**DEFENSE LOGISTICS AGENCY**  
**LAND AND MARITIME**  
**P.O. BOX 3990**  
**COLUMBUS, OHIO 43218-3990**

**SUBJECT:** EP Study to determine final VSWR test method to incorporate vector network analyzers (VNAs) into updated test requirements. Project number 5935-2018-041.

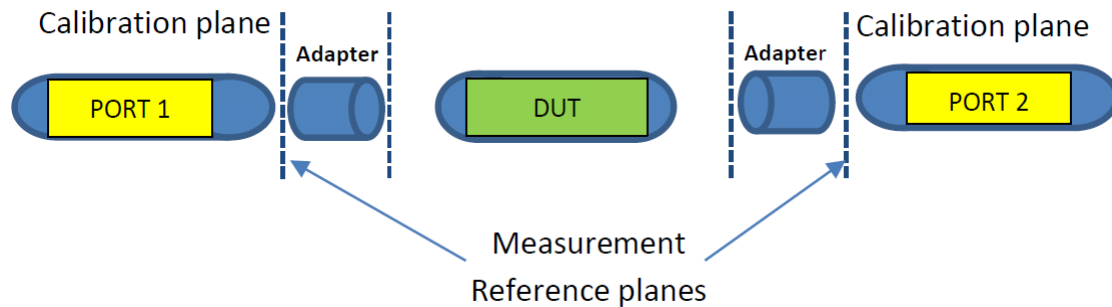
MIL-PRF-39012 will be updated to Method 1:

The VSWR (reflection) shall be measured in accordance to the following approved procedure or a method acceptable to the Government. Part (s) shall be measured using a Network Analyzer. If the DUT (device under test) is not insertable to the calibration port(s), the most practical way is to use a 50-Ohm test adapter or a test fixture.

The following acceptable methods can be used for VSWR (reflection) measurement. Further details on each method can also be found on each manufacturer's network analyzer operation instructions.

*Method 1:* This method includes the effect of the adapter(s) in the DUT measurement trace. Such a pair of test adapters are to be of equal electrical length and meet a VSWR less than  $1.05 + .005 \times F$  (F in GHz). If the DUT (e.g. a cable assembly) including test adapters meets the VSWR requirement, the component is within specifications (with some safety margin) and it can be accepted.
